RE: Storage Building – 4100 Yale NE
Grading Plan
Engineer Stamp Date: 11/24/17
Hydrology File: G16D095F

Based upon the information provided in your submittal received 11/27/2017, the Grading and Drainage Plan **is not** approved for Building Permit, Grading Permit, and SO-19 Permit. The following comments need to be addressed for approval of the above referenced project:

STORAGE BUILDING
4100 YALE BOULEVARD NE
GRADING PLAN

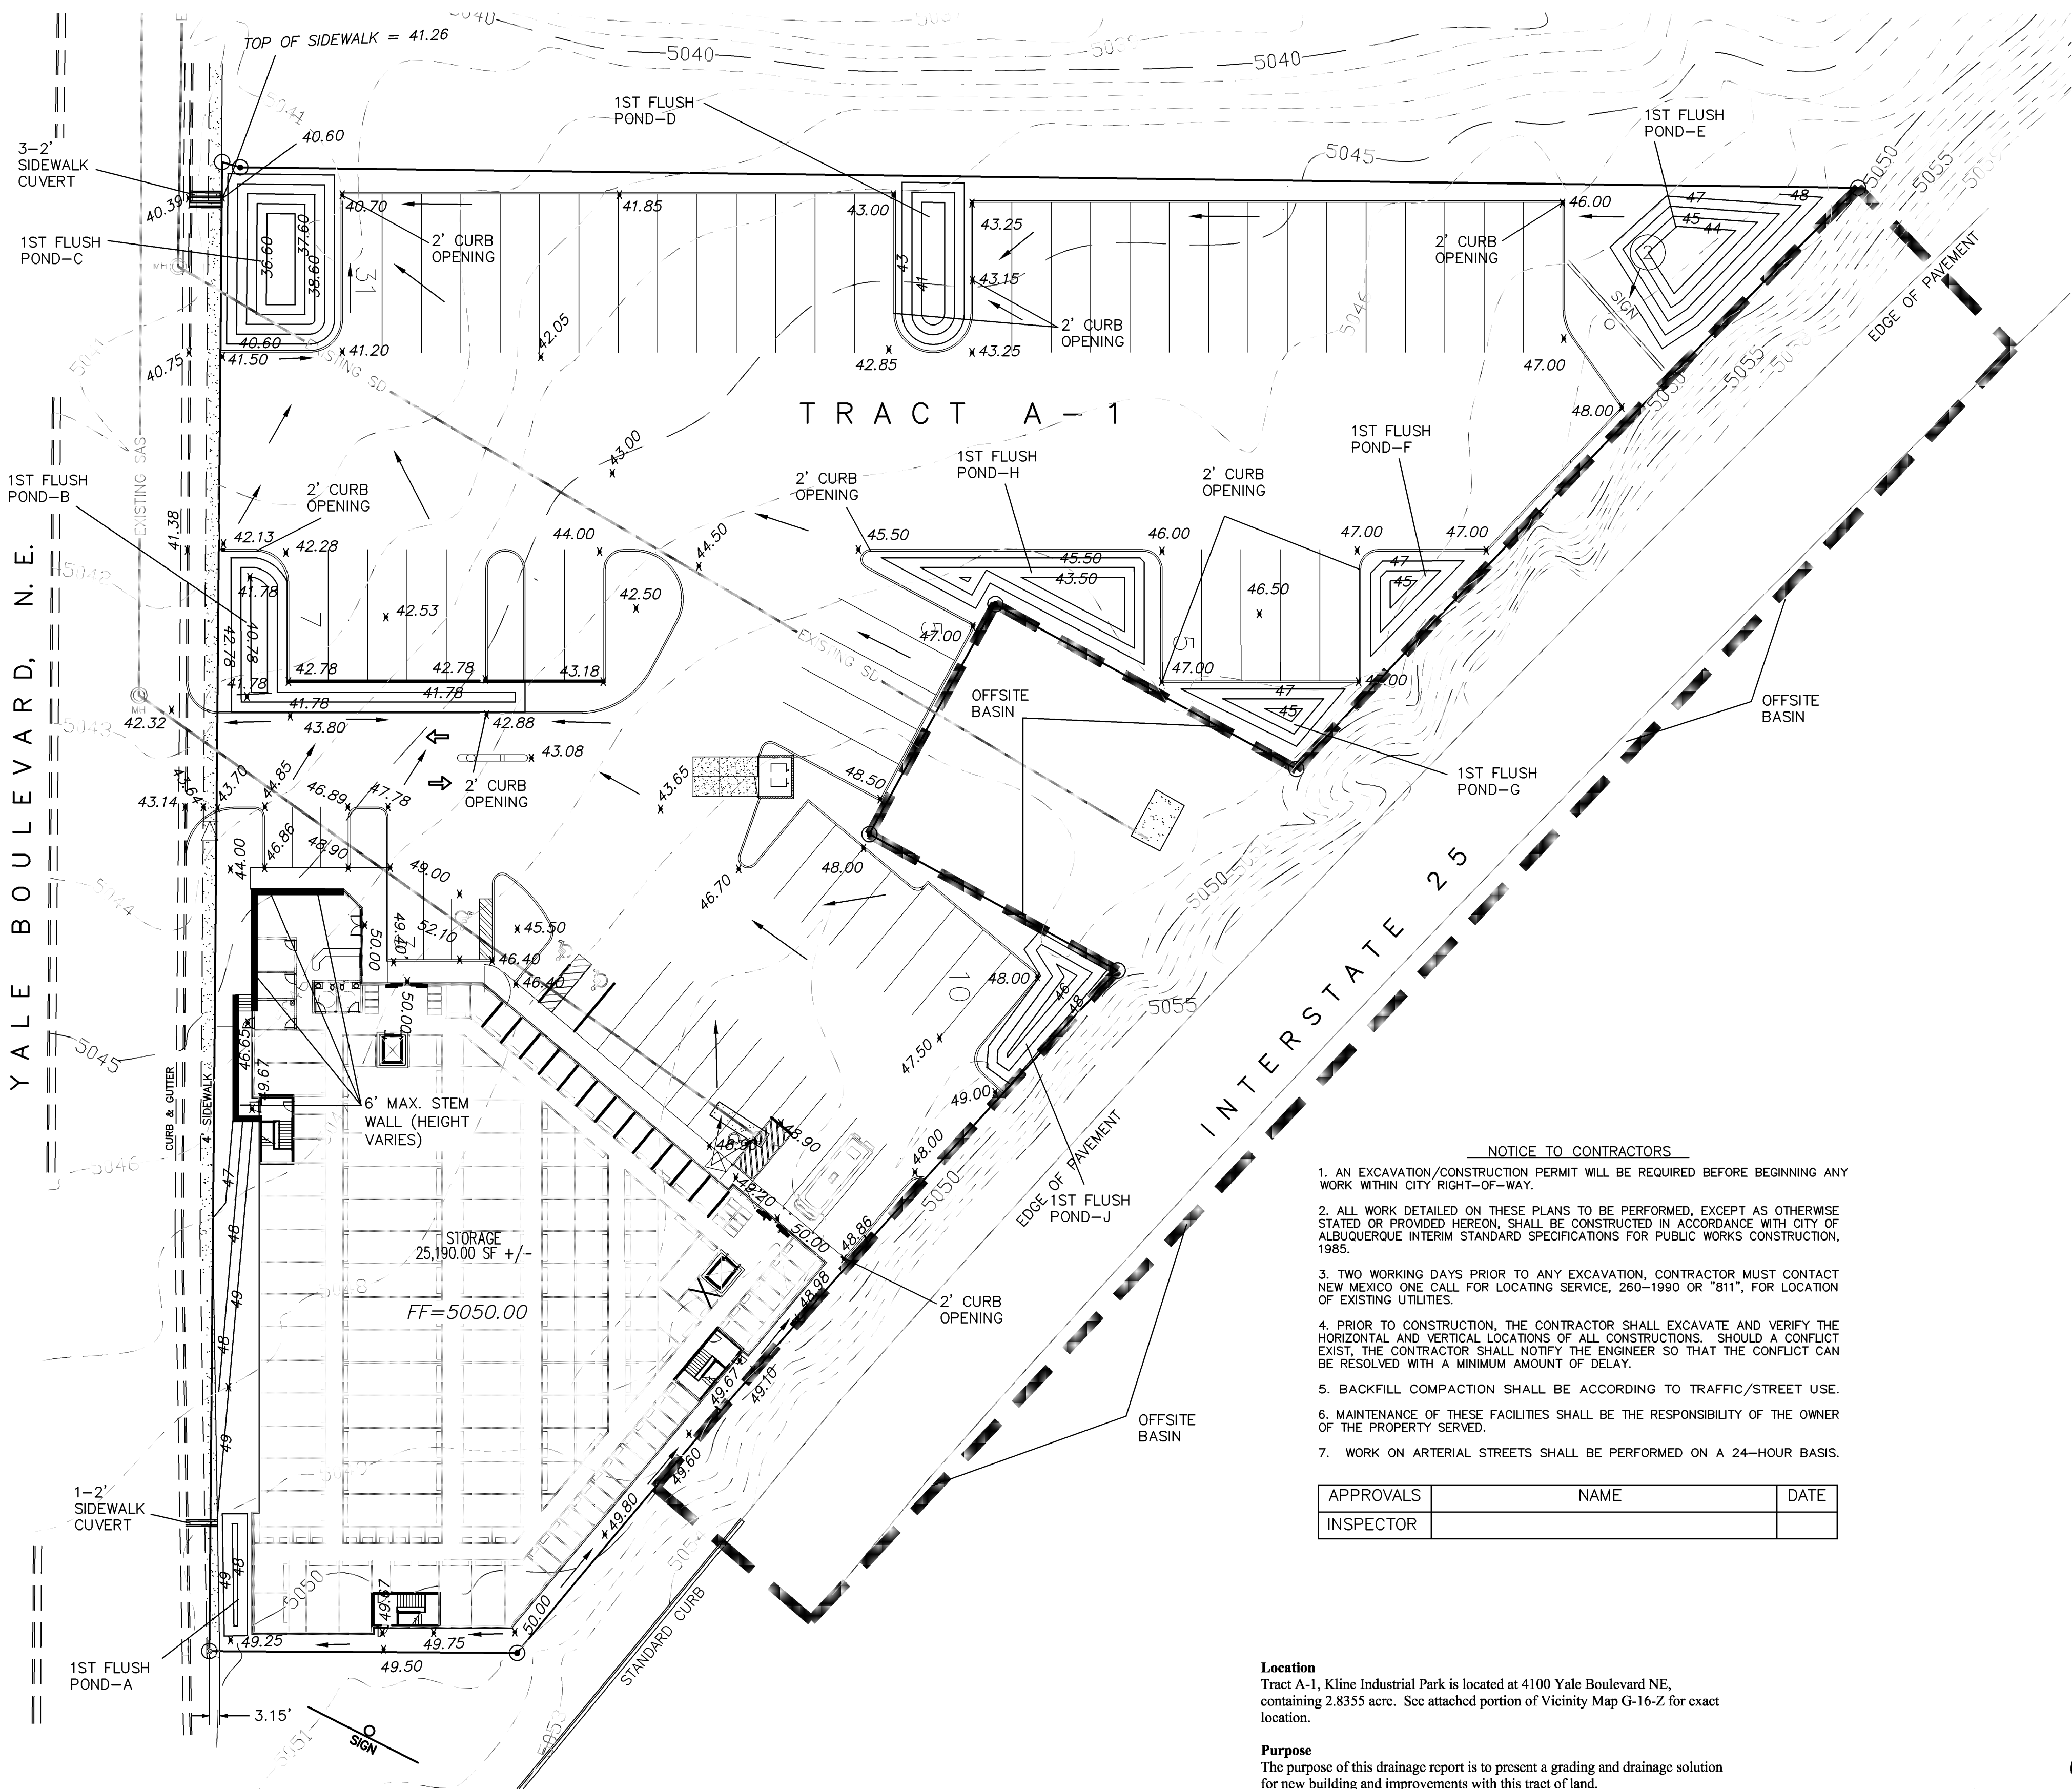
1. Please provide the flood plain effective date to the FIRM information.
2. Please provide the benchmark information for the survey contour information provided.

3. Please show and label the existing 40 feet drainage easement along the existing storm sewer pipe. See attached as-built plan & profile for the storm sewer.

4. Please label the existing storm sewer as “existing 72” public storm sewer”.
5. Please show the water block at the propose driveway.
6. Under the Existing Conditions, it talks about the offsite basin drains west to the site. This is true for portions of the offsite basin. However, there is an existing inlet where you show a piece of concrete. This picks up some drainage which ties into the existing 72” storm sewer. Also the interstate roadway drains to the east, away from the site. Please update both the off-site basin and the calculations for the flow that drains onto the site.

7. Please clean up the calculations. There is a line and overlapping text.

8. First Flush Ponds E, G, H, and J are all on the high side of the site. It is impossible to drain uphill to have these ponds function as first flush basins. Please relocate or consolidate in the ponds downhill where runoff can be treated.
